**ERRATA TO THE
2000 INTERNATIONAL BUILDING CODE**
(Updated March 12, 2003)

Sixth Printing

FIGURE 2110.3.1

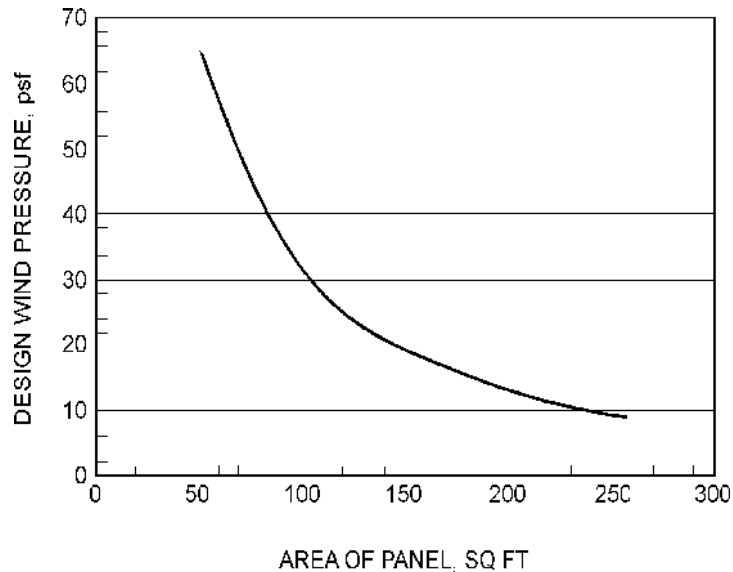
Figure 2110.3.1. Replace figure with the following:
